Revisions
Bubbled areas indicate revisions compared to the previously submitted plans
Received Date
November 30, 2020

SCHOOL DISTRICT 61
VIC HIGH SCHOOL

Sheet Name
Variance Submission for City - Site Plan - Existing

Sheet Name
Variance Submission - Site Plan - New

1 EXISTING SITE PLAN
A3.500 1:500

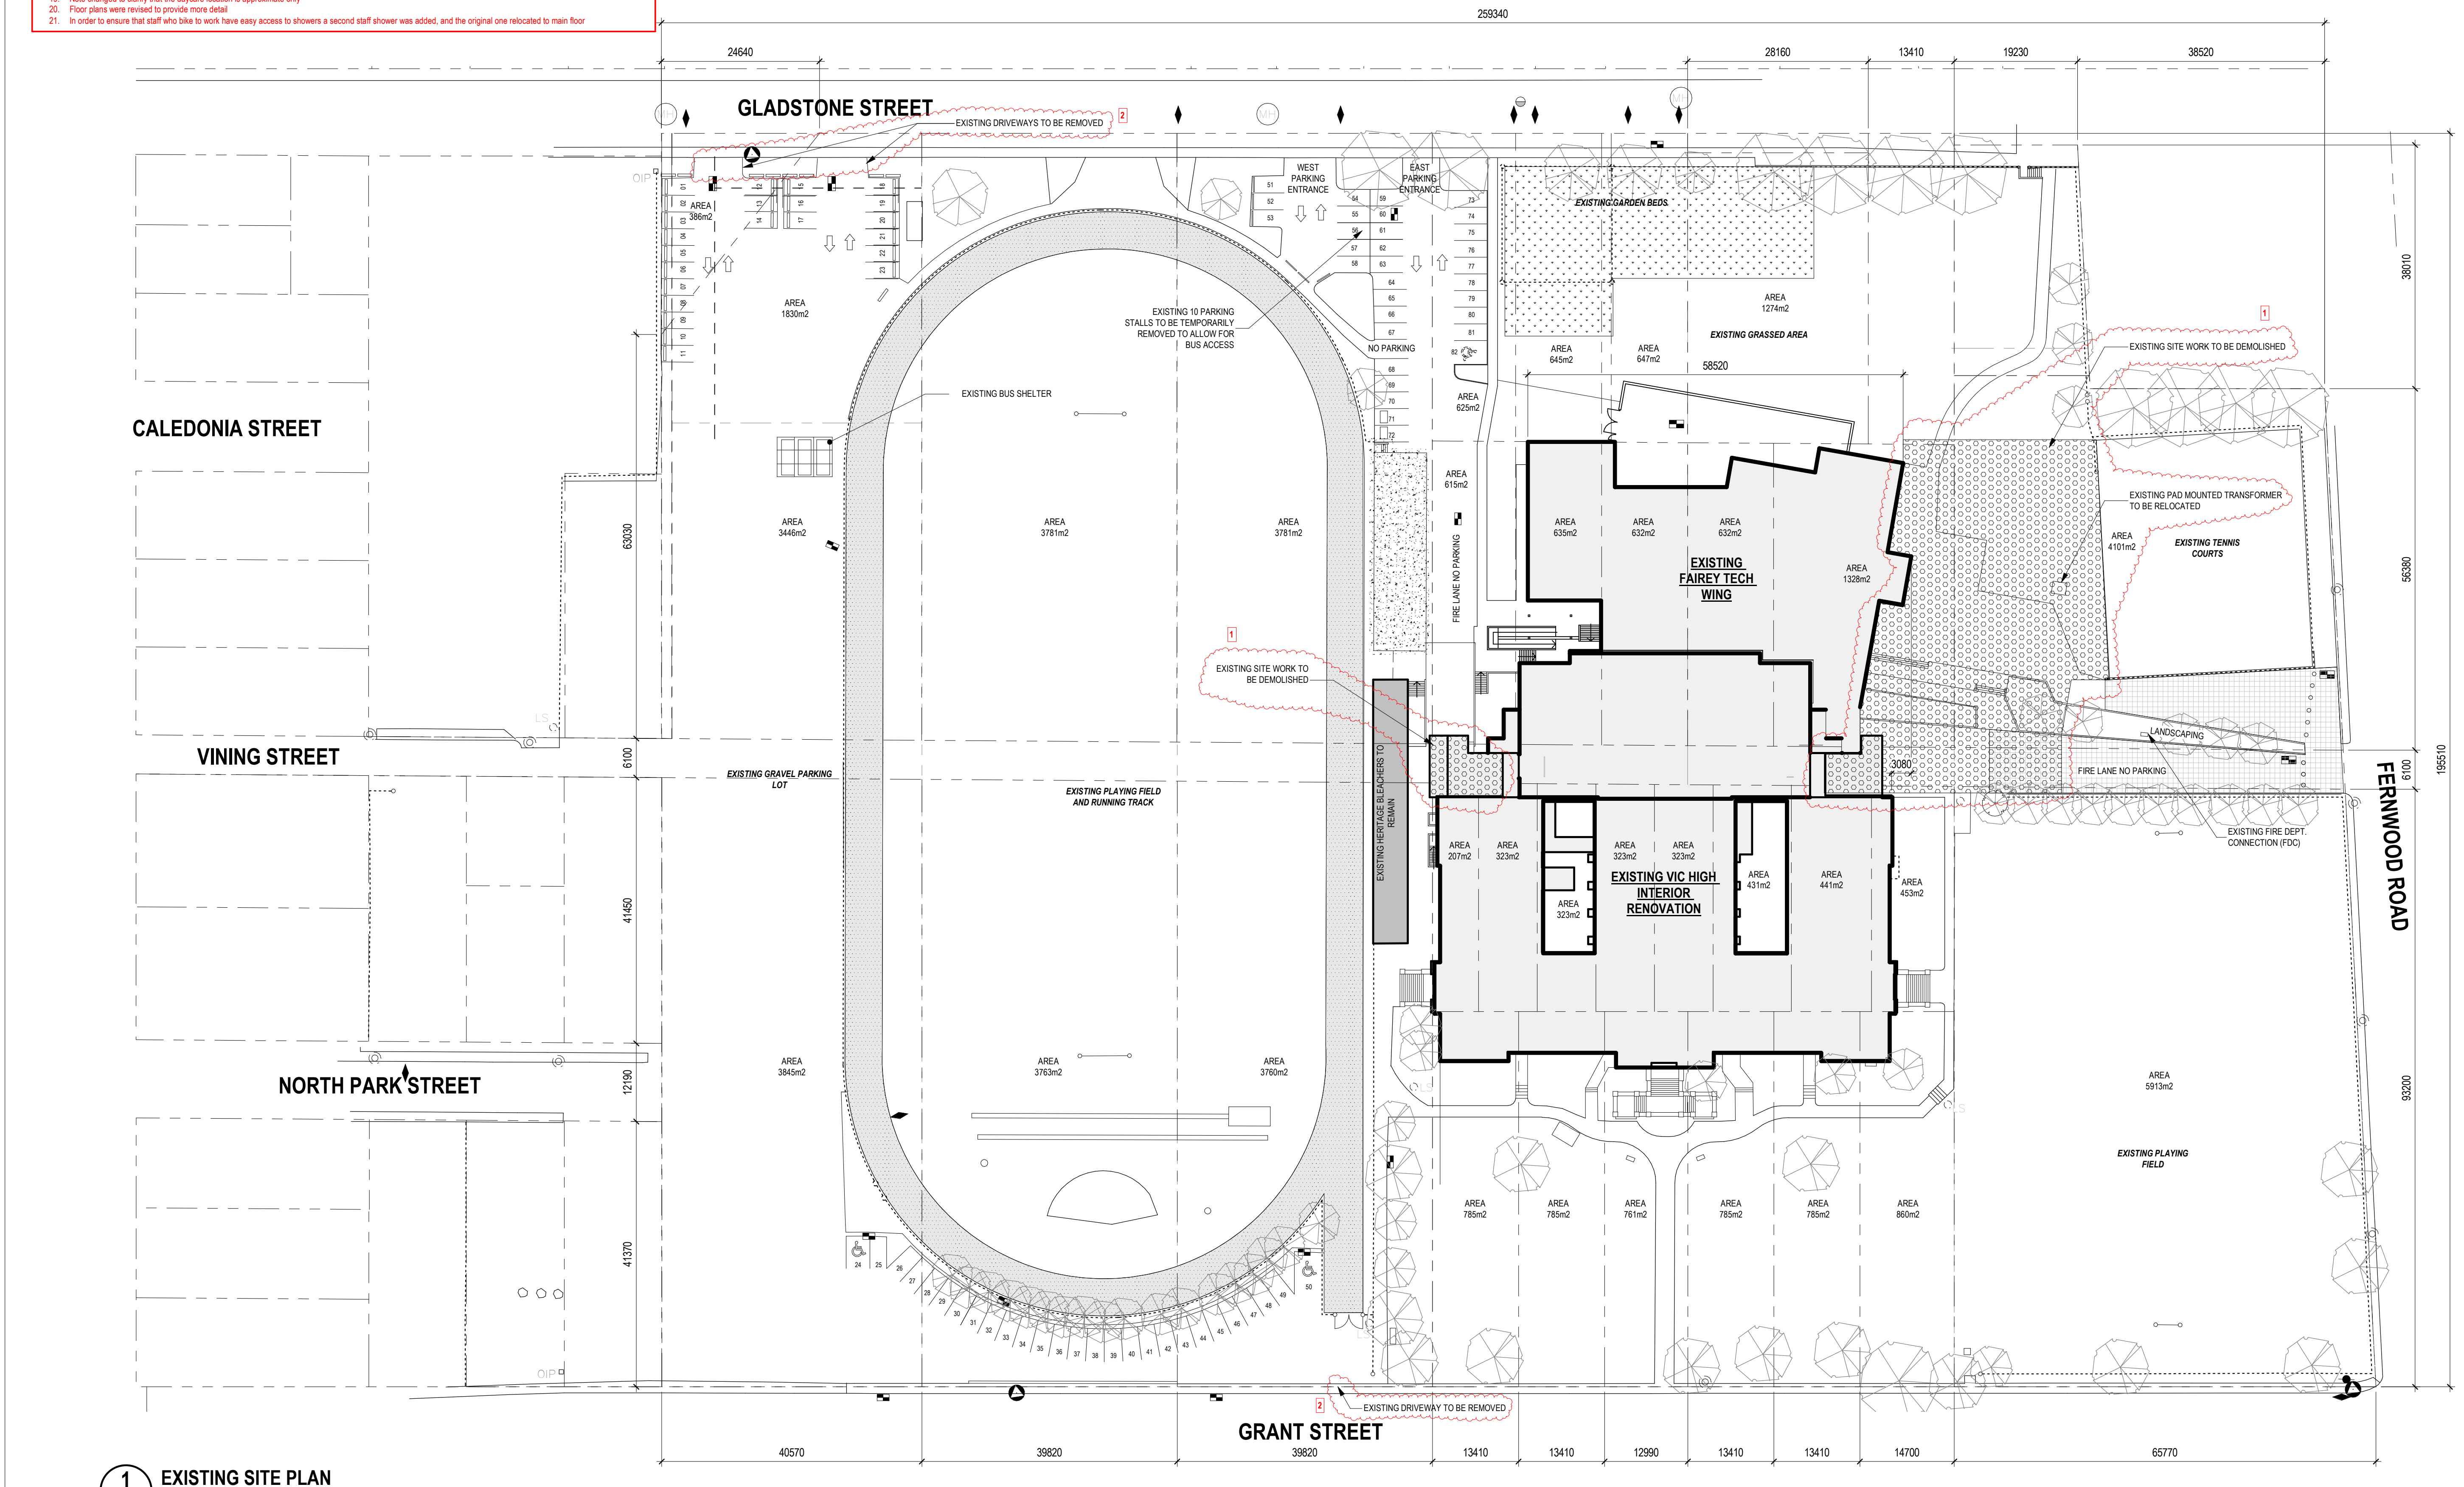
1. Existing site work to be demolished and pad mounted transformer to be relocated
2. Existing driveways to be removed
3. Project data sheet adds: required number of parking stalls corrected, average grade added, open site space and site coverage added, number of stories added, height added

4. Number of bike parking stalls on drawing revised to match the project data sheet, landscaping layout revised, pad mounted transformer relocated
5. Note added to confirm maximum slope of parking areas

2 NEW SITE PLAN
A3.500 1:500

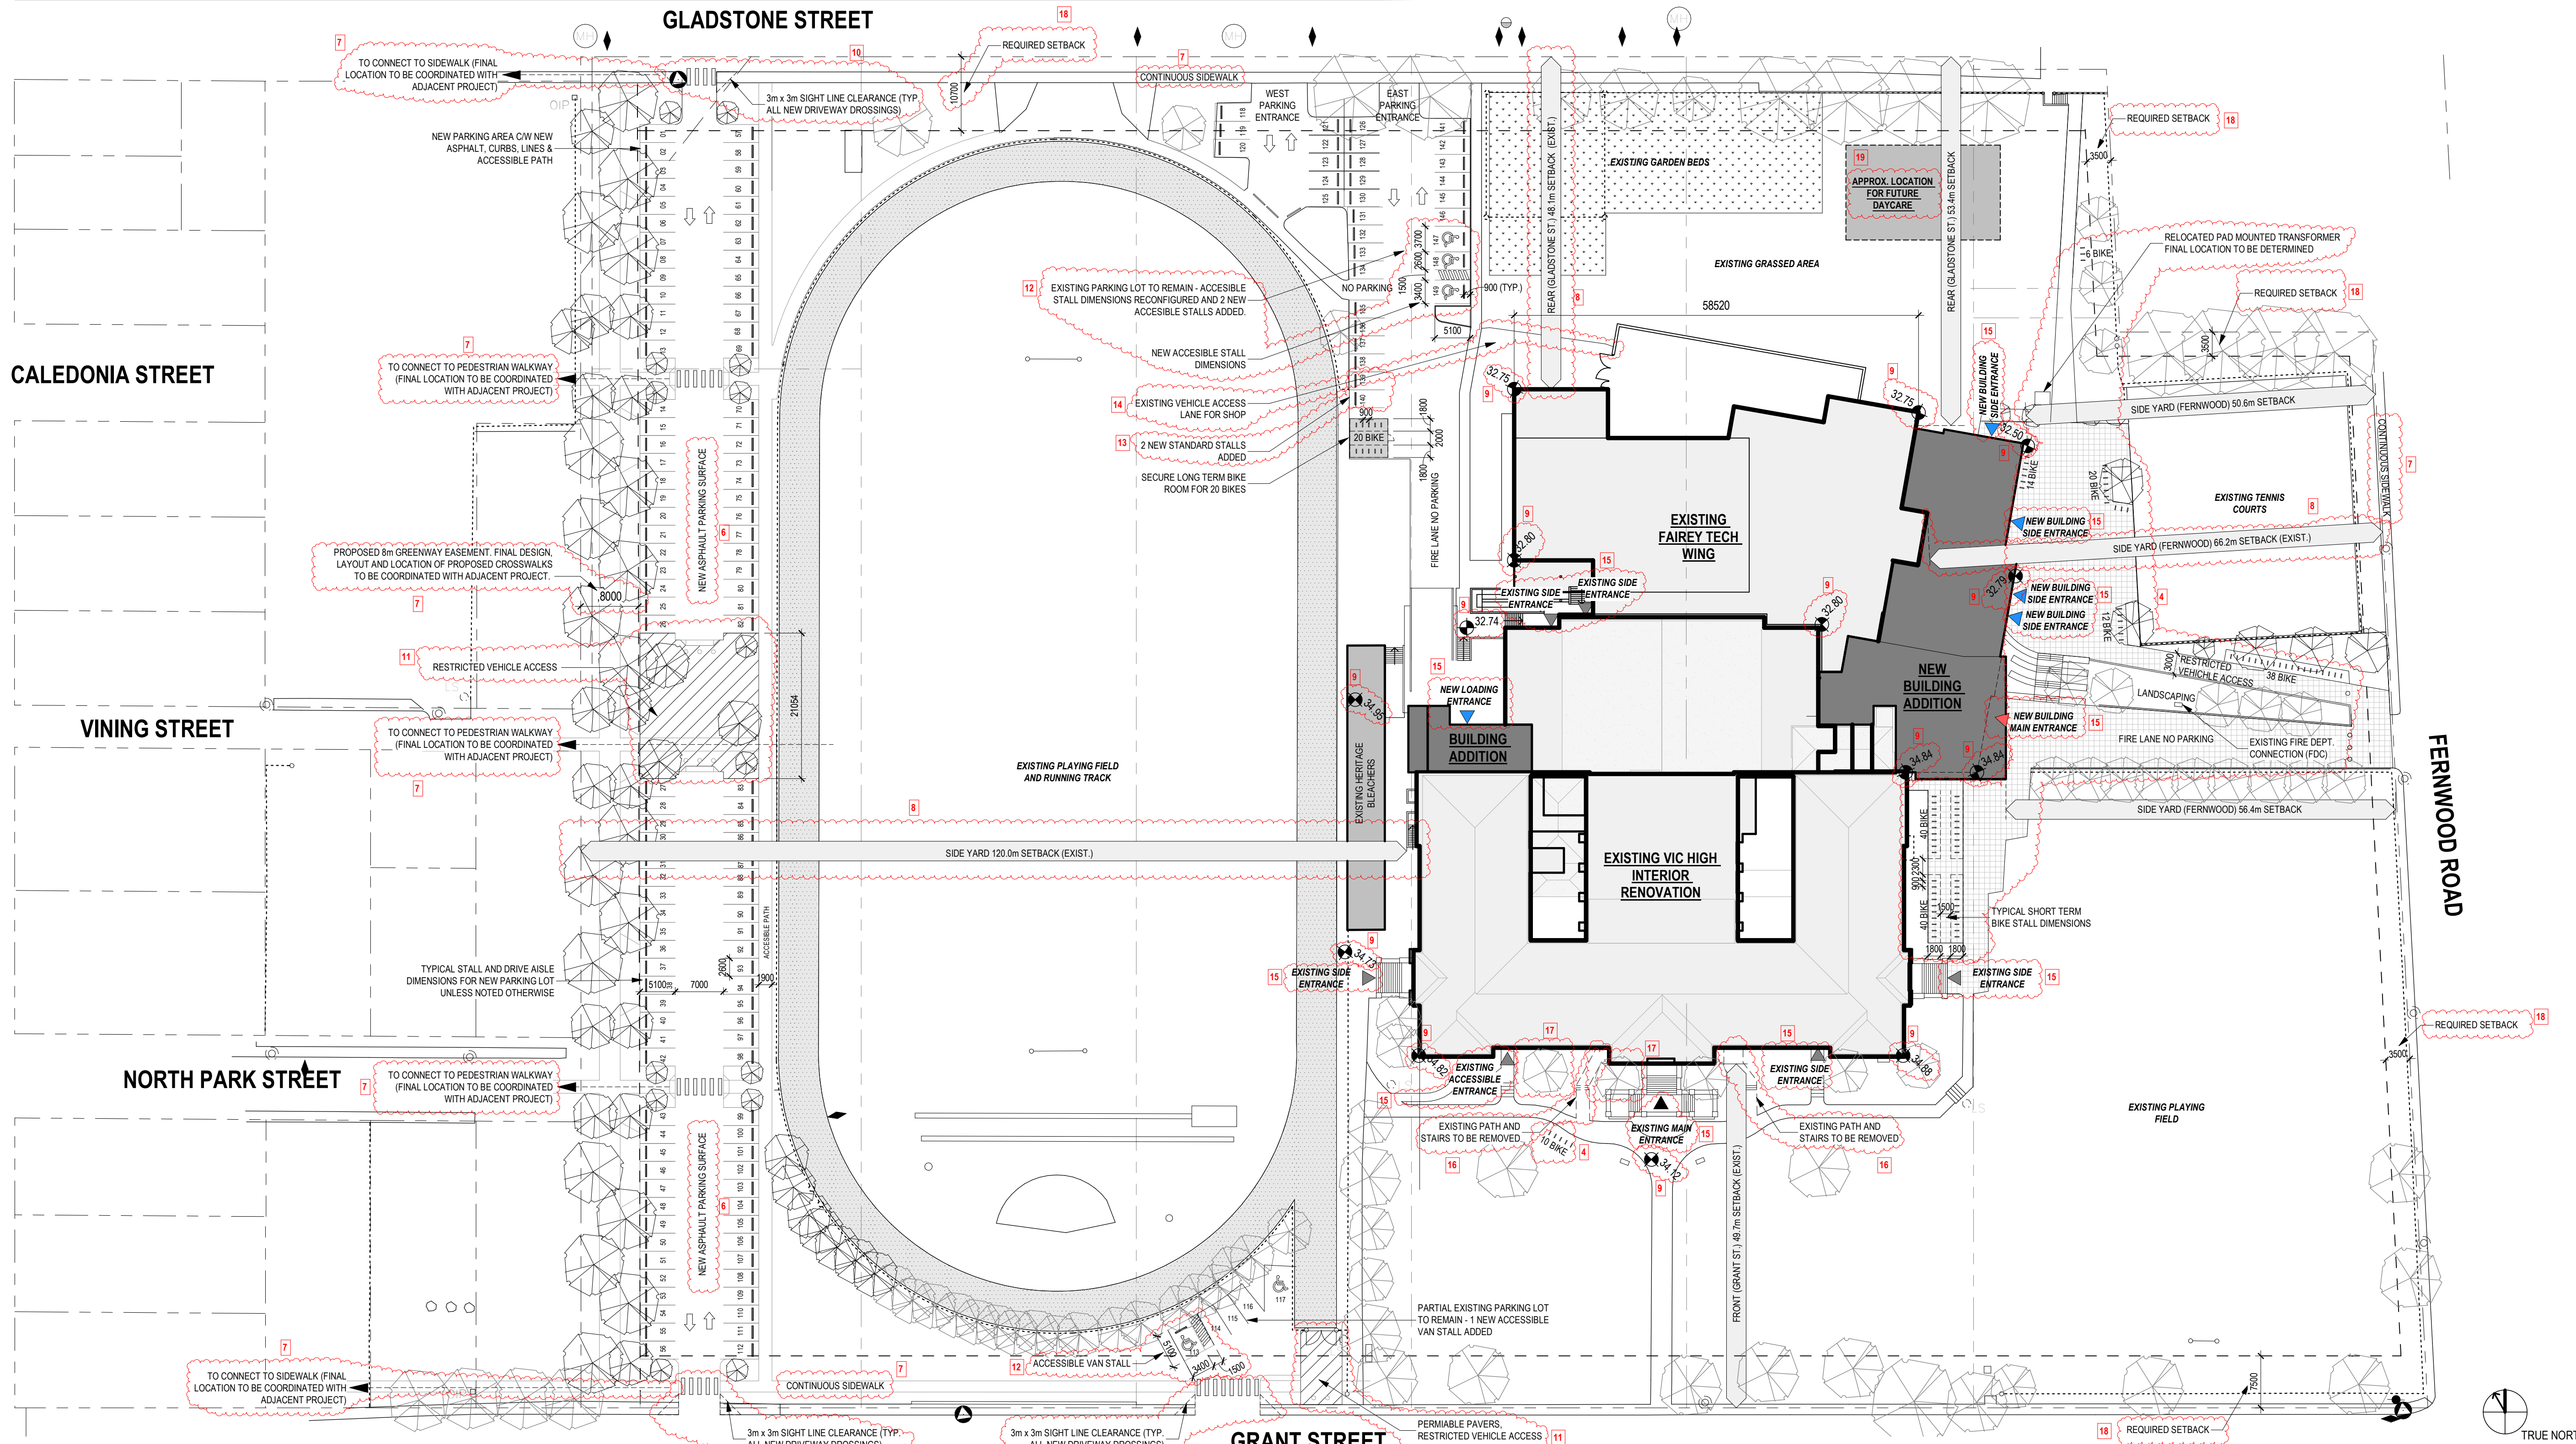
- Existing site work to be demolished and pad mounted transformer to be relocated
- Existing driveways to be removed
- Project data sheet edits: required number of parking stalls corrected, average grade added, open site space and site coverage added, number of storeys added, height added

- Number of bike parking stalls on drawing revised to match the project data sheet, landscaping layout revised, pad mounted transformer relocated
- Note added to confirm maximum slope of parking areas

- Note added to confirm material used for parking surfaces
- Notes added to clarify continuous sidewalk locations and general coordination with adjacent project

- Annotations added to clarify setbacks to existing building on Gladstone, Fernwood, and interior lot line
- Point elevations added
- Cross walks and sight line clearances added on driveway crossings

- Handing added to denote areas with restricted vehicle access
- Accessible parking stalls reconfigured
- Note added to clarify that 2 new standard stalls are being added to the existing South parking lot

- Existing vehicle access lane for shop added
- Building entrance markers added
- Note added clarifying which existing paths and stairs are to be removed

- Missing trees added
- Notes added to clarify where required setback dimensions are
- Note changed to clarify that the daycare location is approximate only
